SDP Submittal #5 – Comment Response

2. Site development plan sheet 12

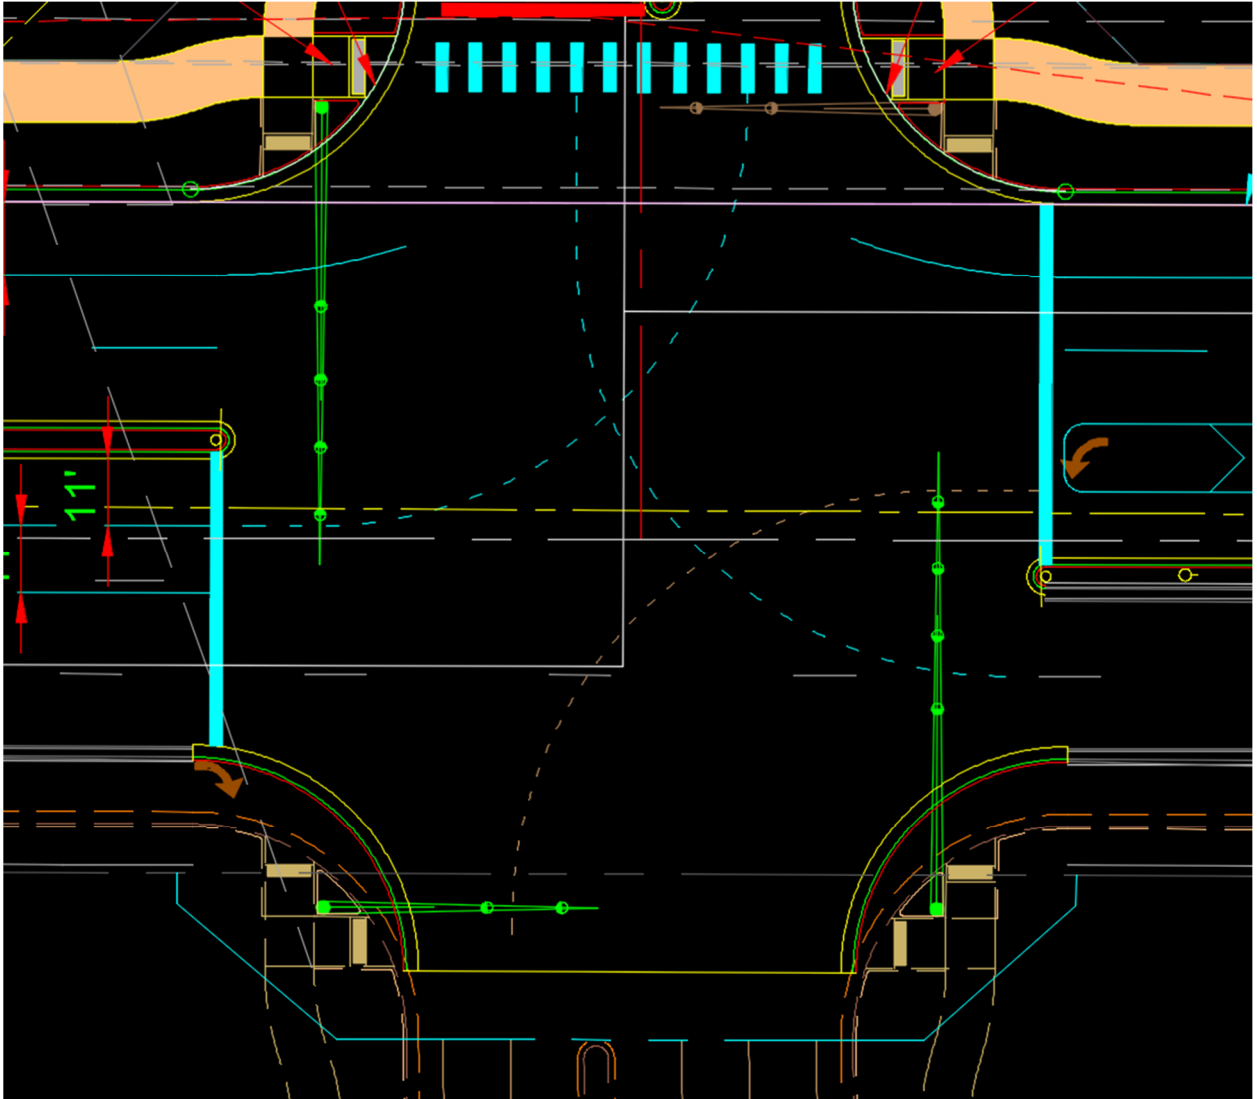
The WB to SB left turn lane is labelled as 11 wide, but that may include the theoretical 1 shoulder/gutter, making it a 10 lane. How far is traffic from the edge of any median posted signs?

Response: The widths provided are from stripe to edge of pavement. The turn lane has 11' of asphalt. The signs post will be 3.5-feet from the edge of pavement.
